DIREZIONE
ASSISTENZA CLIENTI

**INFORMATION SHEET
IMPROVEMENT BULLETIN
TECHNICAL BULLETIN**

up to 31st May 1967

CONTENTS

FUEL SUPPLY LINE

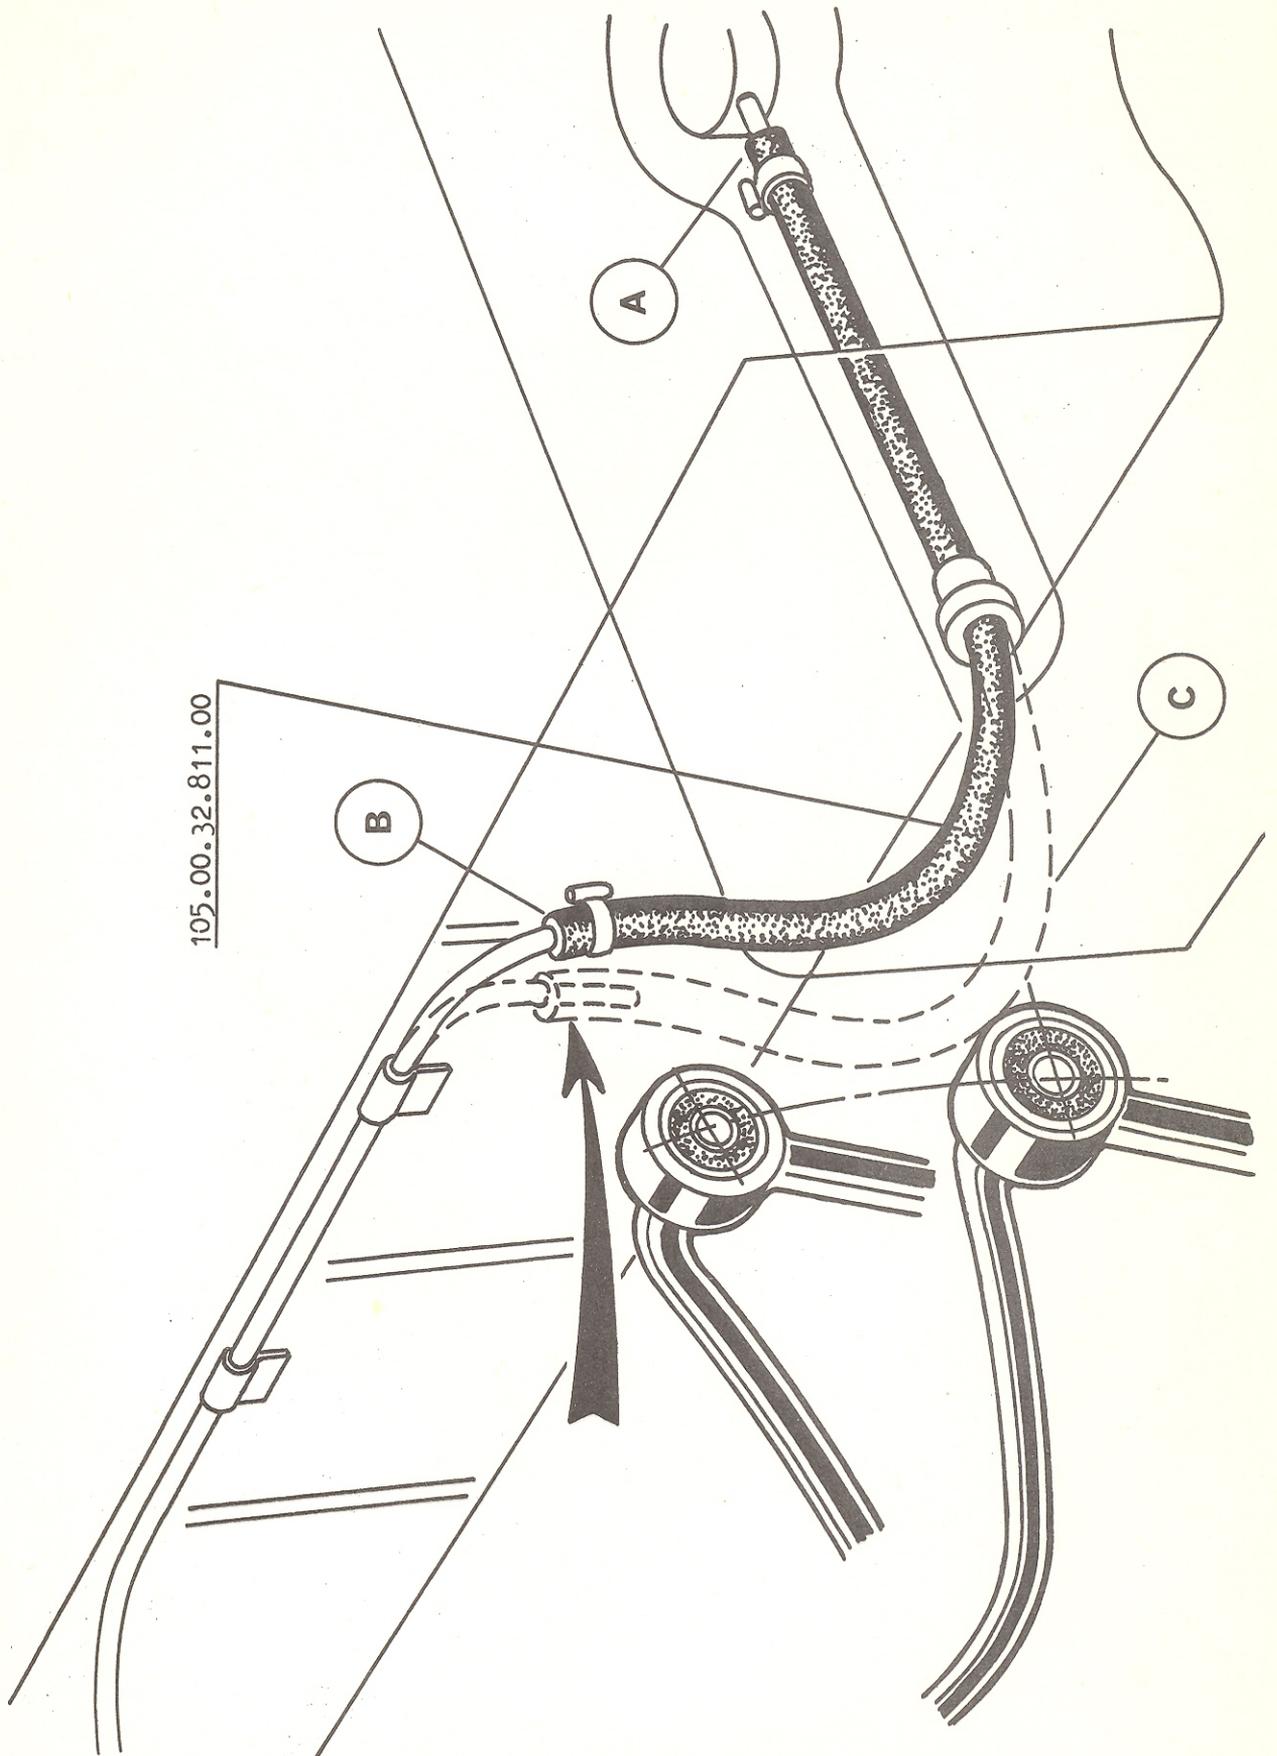
In order to prevent the rear stabilizer rod link from interfering with the plastic hose connecting the fuel tank to the pipe on the underfloor, the plastic hose, P.N. 105.00.32.811.00, must be bent as shown in the illustration.

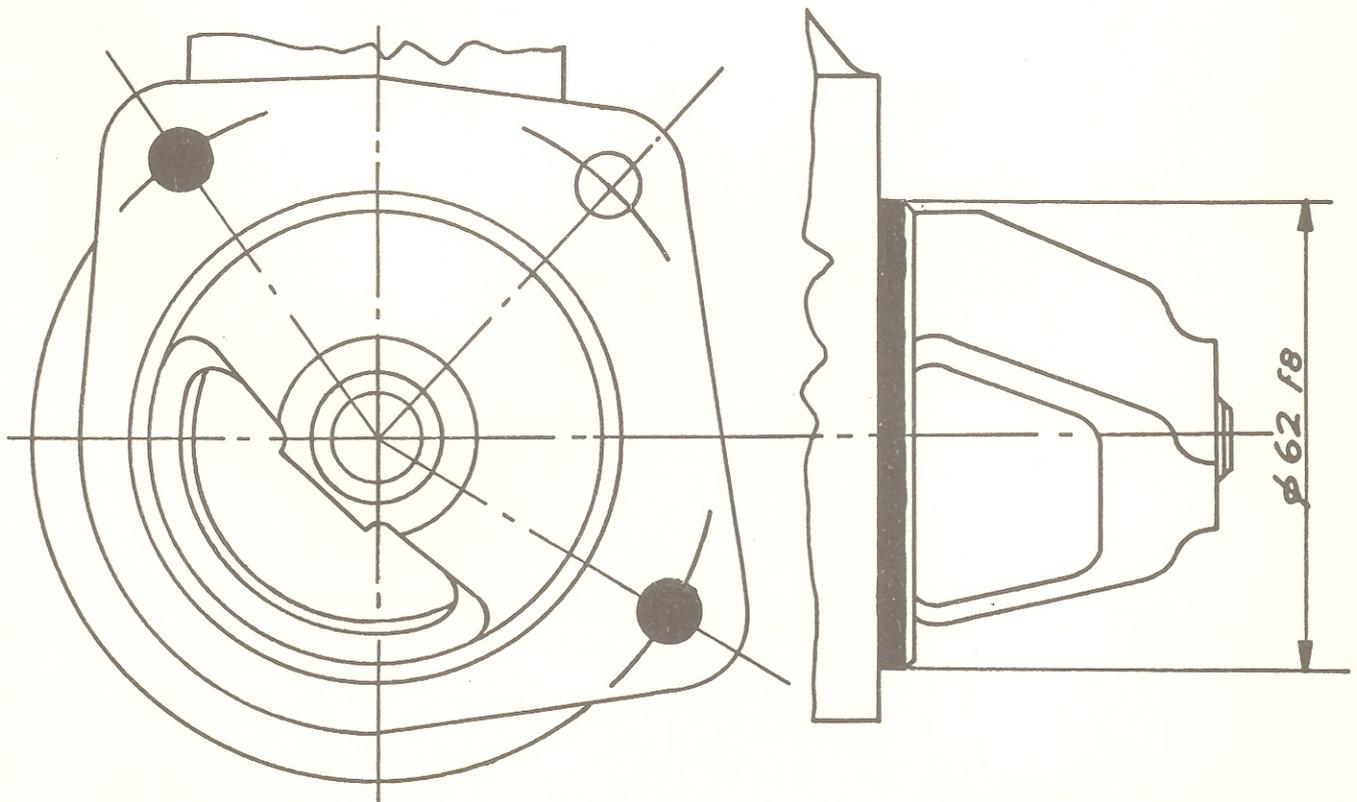
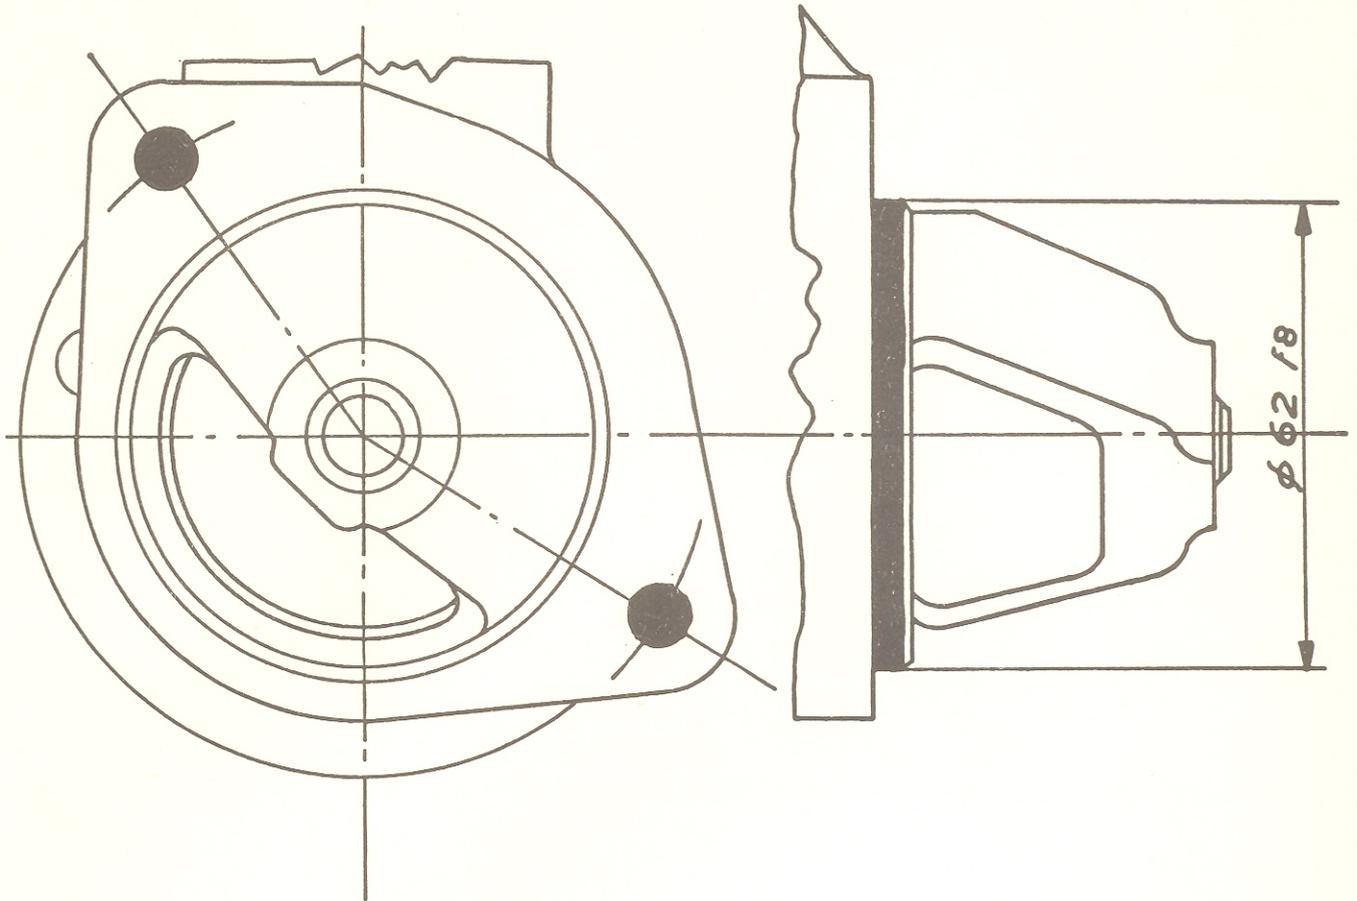
The third hole in mounting flange of new motor will not be used on installation.

When the 62 mm dia. collar fits properly the seat (see figure), the starting motor will correctly be centered in place.

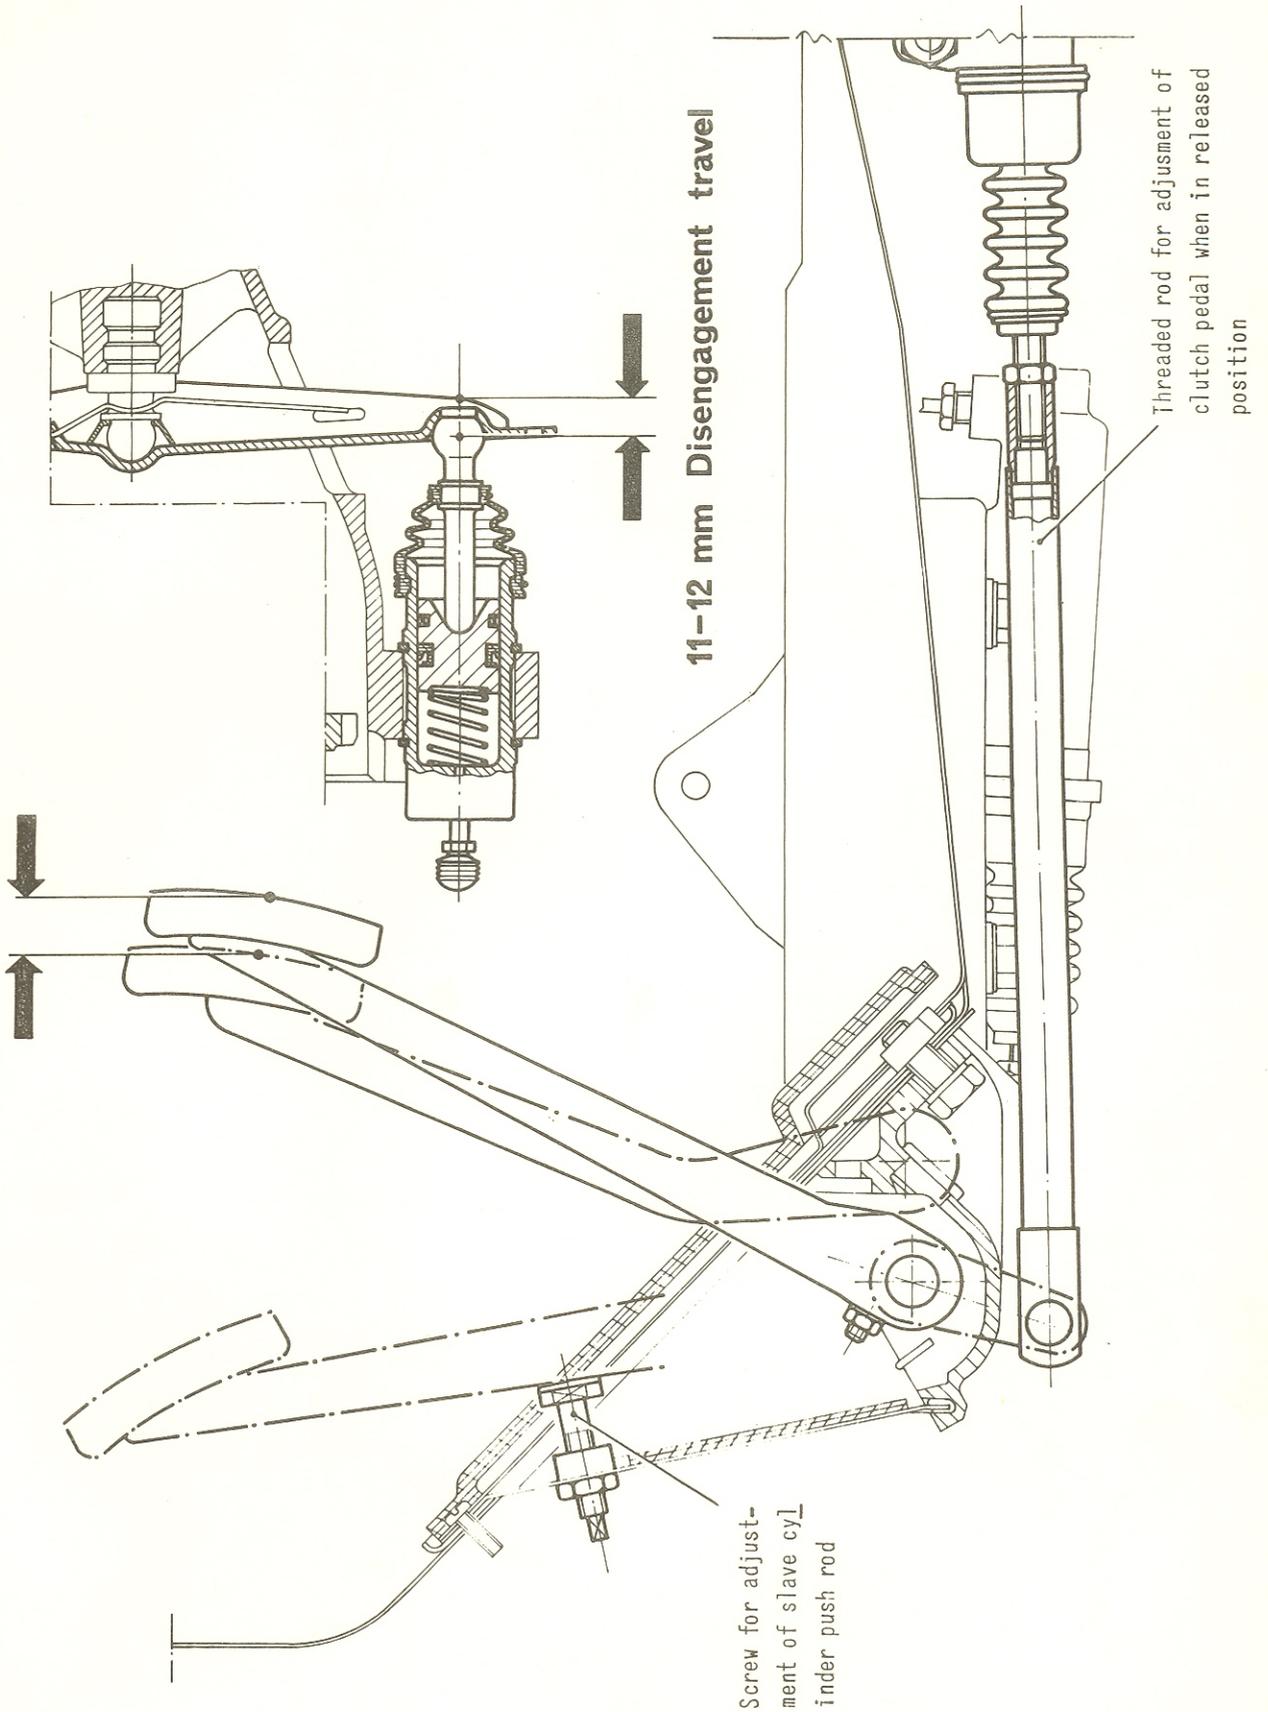
18 mm (.71") for L.H.D.
12 mm (.47") for R.H.D.

If adjustment is needed, act on the threaded rod. See figure.
